**GOVERNMENT OF TELANGANA
FOREST DEPARTMENT**

Ref.No.FC4/FC29/1/2022(I) Dated:27/06/2024.

Sub: TGFD -FC(A)ct, 1980- Diversion of 151.8517 Ha of forest land falling in Yellandu division for proposed Jawahar Khani OC project at Yellandu division in favour of M/s Singareni Collieries Company Limited - **Additional Information Sought by GoI, MoEF & CC, New Delhi** -Regarding.

Sub:- Proposal for diversion of 151.8517 Ha. of Forest Land in Yellandu Division for JKOC Project (Online proposal FP/TG/MIN/49581/2020) - MoEF&CC, Gol raised EDS-4 on 16.05.2024 - furnishing the reply to the EDS-4 -Reg.

PLAN SHOWING THE AREAS OF REHABILITATED DUMPS
AT JKOC-II PROPOSED FOR HANDING OVER TO STATE
FOREST DEPARTMENT UNDER CA SCHEME
YELLANDU AREA

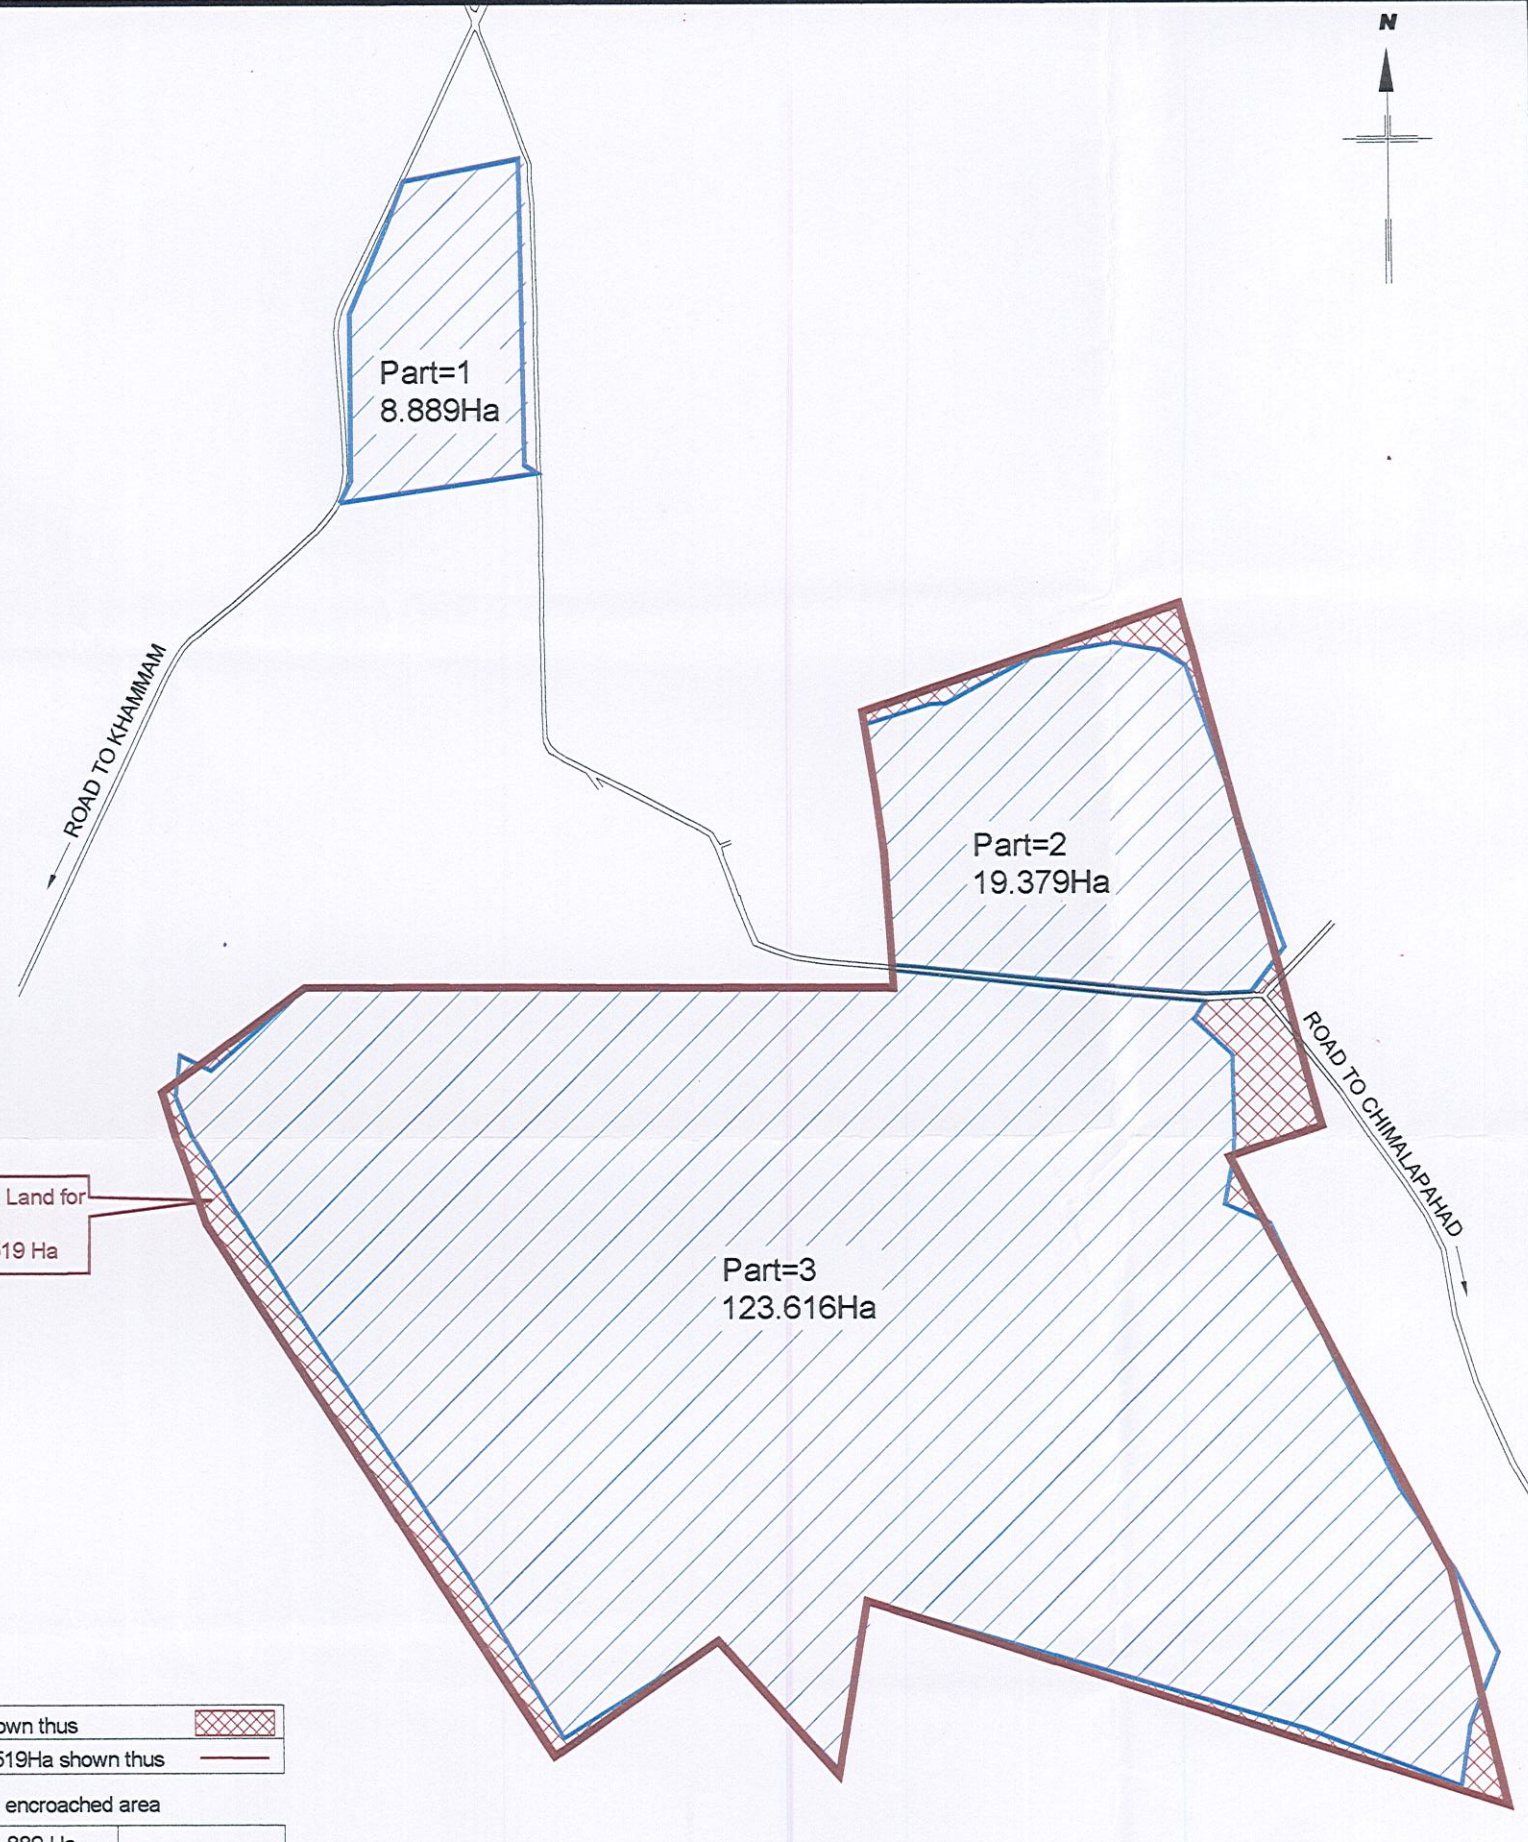
Point No.v:- As per the site inspection report by the Regional Office the exact area proposed for the CA (NFL-rehabilitated OB dump area), is not demarcated completely (verified and measured) and there may be a possibility of encroachment in the fringe areas. In this regard the State Govt. shall demarcate the area and submit exact details along with plan to protect the said area for its protection and management.

The Proposed CA land of 151.8517 Ha. was resurveyed and demarcated completely (verified & measured). Out of 151.8517 Ha of given CA land an extent of 8.889 Ha. was identified with encroachments at fringes.

SCCL identified the alternate CA land in the adjacent area. The KML file of 8.889 Ha of alternate CA land is enclosed in pen drive.

It is requested to arrange for inspection of alternate CA land of 8.889 Ha by the District Forest Officer, Khammam and submit the report to the Principal Chief Conservator of Forests. Copy of Plan showing the alternate CA land of 8.889 Ha is enclosed as Annexure-VI.
